Product Change Notification / MAAN-07HTDL444

CCB 6544 Initial Notice: Qualification of HANA as an additional assembly site for selected MCP1791Txx device family available in 5L SOT-223 package.

CCB 6544
Pre and Post Change Summary
PCN #: MAAN-07HTDL444

LPI

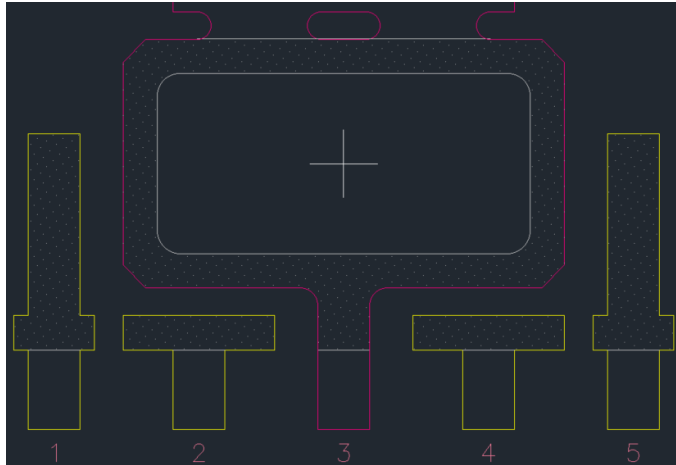
Lead-Frame Paddle Size	152x86mils
Lead-Frame Material	C194

HANA

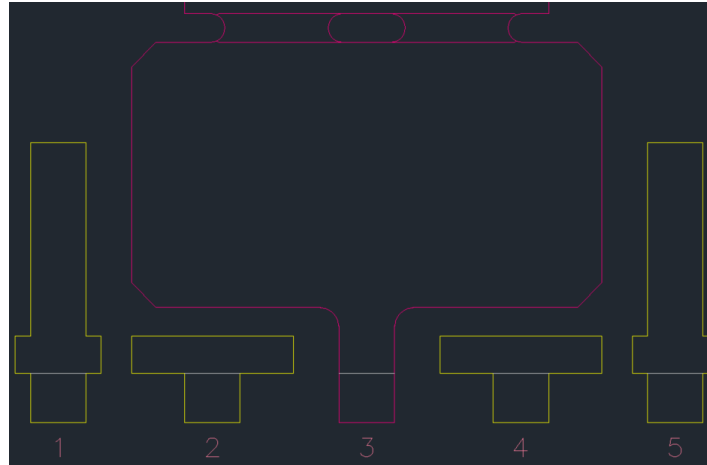
Lead-Frame Paddle Size	152x86mils
Lead-Frame Material	C194

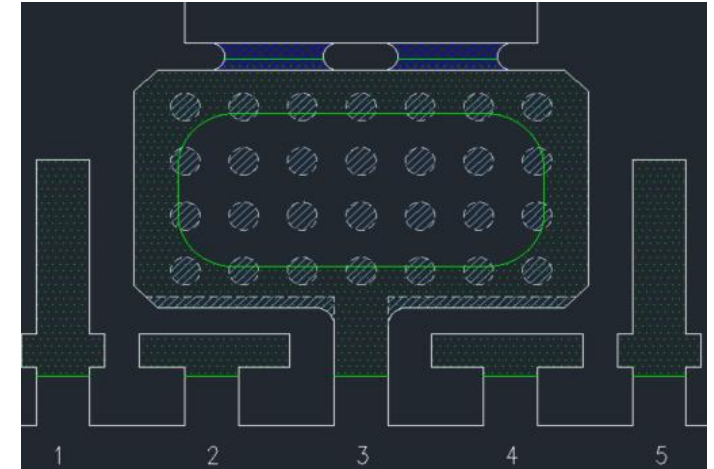
Lead-Frame Paddle Size	152x86mils
Lead-Frame Material	C194
